MEMORANDUM

TO: Greg Contaldo  
FROM: Pam Egan  
DATE: May 17, 1993  
RE: BW-4

BW-4

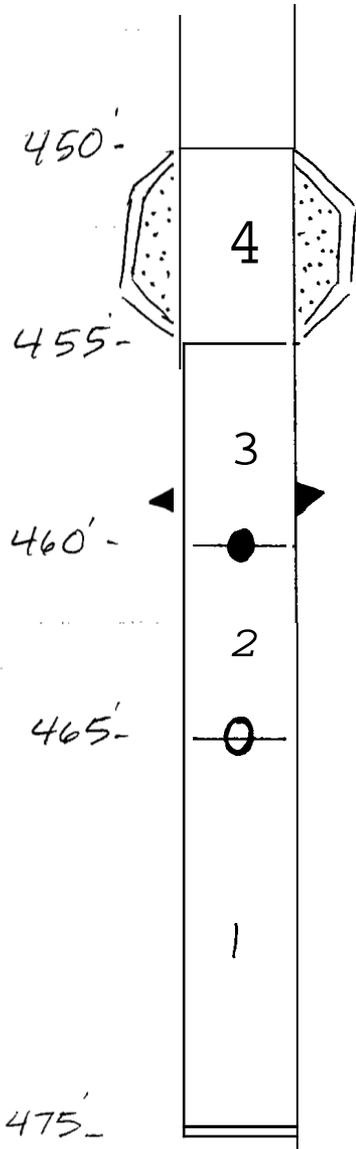
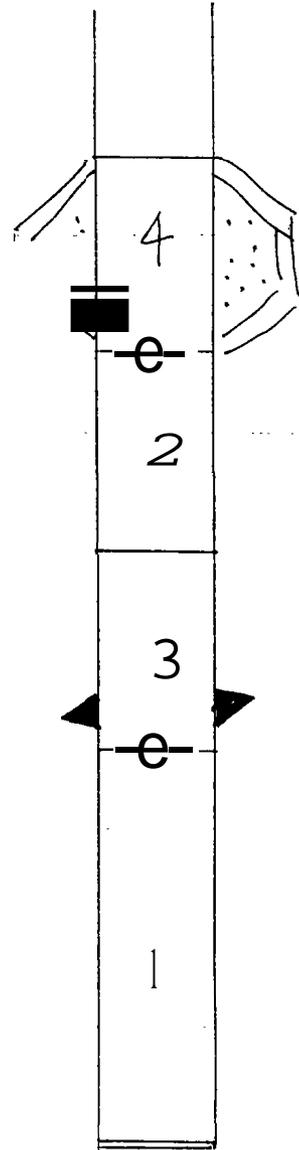
During the completion of monitoring well BW-4 on 3-10-93, the H+GCL field crew inadvertently installed two pieces of Westbay casing out of sequence from the proposed well design. The events leading up to this incident are as follows:

Attached are drawings of both the proposed and actual well design of sampling zone #1. A copy of this memo has been placed in the **BW-4** well file folder.

Actual Sequence with casing #2 & #3 reversed.

It is our (Dave, Kyle, and myself) opinion that this error in the **casing** sequence does not, in any way, compromise the integrity of well **BW-4**, create any development problems, nor does it effect the quality of groundwater samples extracted from this sampling zone. **An** inquiry made to Dave Mercer of Westbay Instruments, Inc. confirmed that this situation would not create any kind of problem.
